DEVELOPMENT SERVICES DEPARTMENT STAFF REPORT

Project Name: Nove of Margate

DRC #: 23-400013

Application Type: Rezoning

[Applicant's Open Space Exhibit]

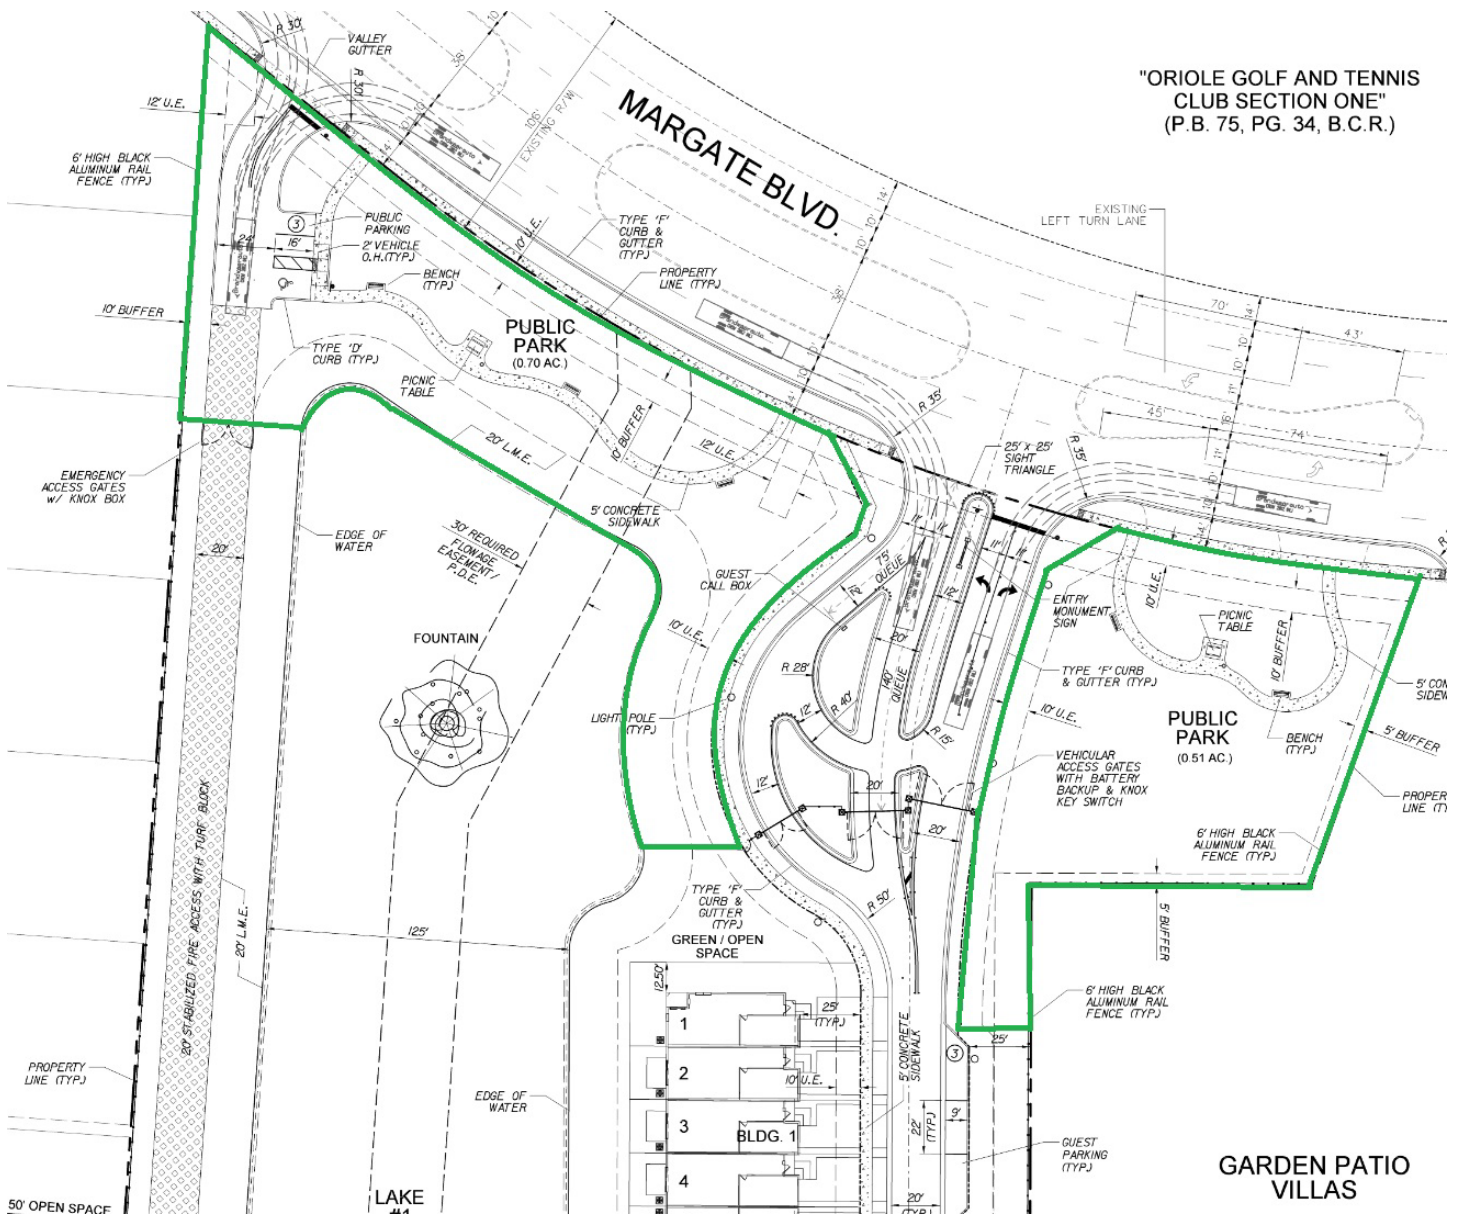
Either cite the verbiage in Sec. 19.11 (MZC) that allows this area to credit the open space requirement or remove it from the tabulation.

Either cite the verbiage in Sec. 19.11 (MZC) that allows this area to credit the open space requirement or remove it from the tabulation.

Revise gross acreage of 'residential lot' to only include fenced in portions of yards, per Sec. 19.11 (MZC).

Tabulation of 'other open space' includes a number of areas not specifically described in Section 19.11 (MZC). Revise.

Response: A new sheet, Open Space Exhibit (Sheet SP-06) has been provided with this submittal. This plan shows all the areas included in the calculations in green. The definition of Open Space listed in Section 19.3 of the City Code permits this section to be counted towards the open space. Specifically, the definition of Open Space is as follows: "Open space: A generally unobstructed parcel or area of land permanently dedicated or reserved for the use and enjoyment of owners and occupants of the land within the PUD. Required open space shall be of a pervious nature and shall not be used for private roadways open to vehicular circulation; off-street parking or loading berths, lakes, canals, and other features may be considered as required open spaces to the extent of the limitations contained herein at Section 19.11, "Open Space Requirement and Computation." As this area is a generally unobstructed area of land permanently dedicated for the use of and enjoyment of the owners within the PUD, it meets the definition of Open Space and can therefore be counted towards meeting the open space requirements. More importantly, the PUD provides substantially more open space than required by Code.
